**June 11, 2020
Staff Report to the Southeast Town
Design Review Committee**

CASE #MPL2020-10036

ADVENT HEALTH AT LAKE NONA HEALTH PARK

ARCHITECTURAL ELEVATIONS

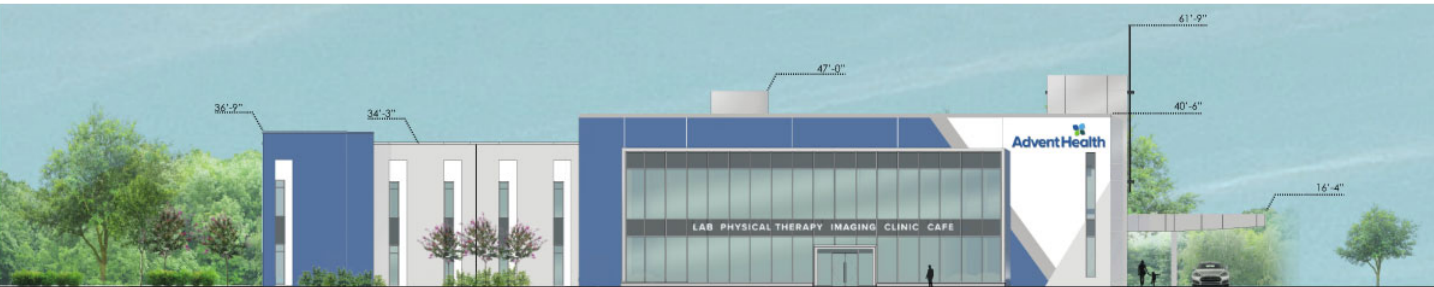
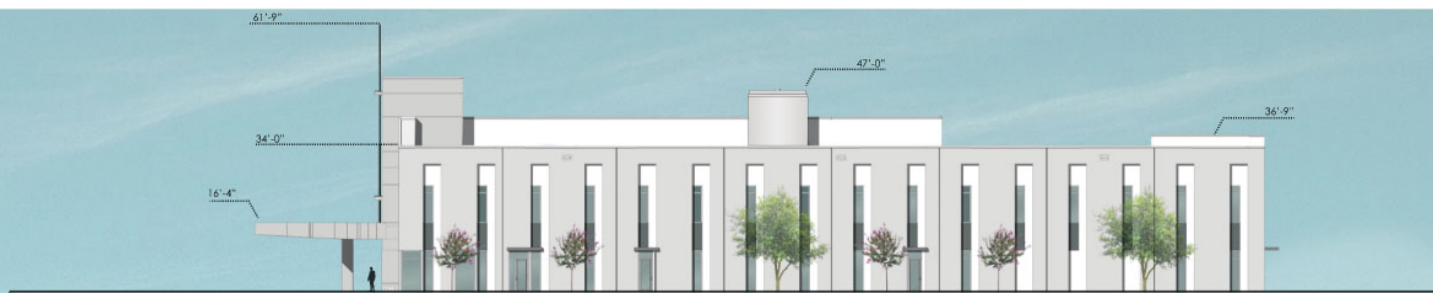
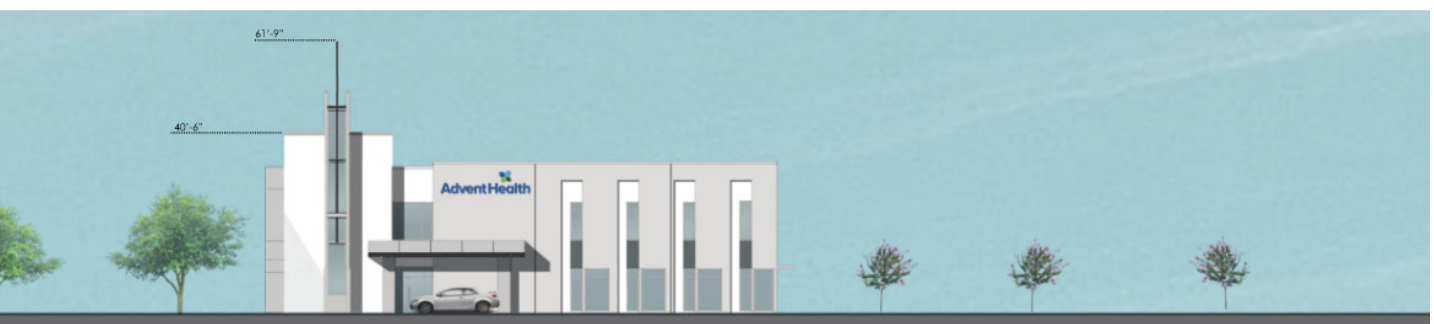
The applicant did not submit a complete signage package, however, the elevations indicate possible high-rise signs (above 30 feet) on the building on two (2) sides. According LDC Section 64.246, "Up to two high rise building identification signs are allowed per building. If two such signs are installed, they must be placed on two separate sides of the building and both must be identical in size, color, shape, design, material, and copy..."

Also, according to LDC Section 64.246, "high rise building identification signs are prohibited within 1,000 of R-1 or R-2 zoning district unless approved by conditional use permit." The Enclave at Villagewalk is immediately adjacent on the west site of the subject site. With this requirement, the applicant must submit for a Conditional Use Permit to the Municipal Planning Board for any high-rise sign on the medical office building. The high-rise signs depicted are not approved as part of this SPMP submittal.

The applicant has not provided signage details such as height of monument signs or copy area of each sign including the high-rise signs. A master signage plan for this development is required prior to building permits. All signage shall be consistent with Chapter 64 of the LDC and Lake Nona Master Sign Plan.

The applicant must submit for a Conditional Use Permit to the Municipal Planning Board for any high-rise sign on the medical office building due to being within the 1,000 feet from a residential zoning district. High-rise signs are limited to two (2) sides of the building only. They must be placed on two separate sides of the building and both must be identical in size, color, shape, design, material, and copy.
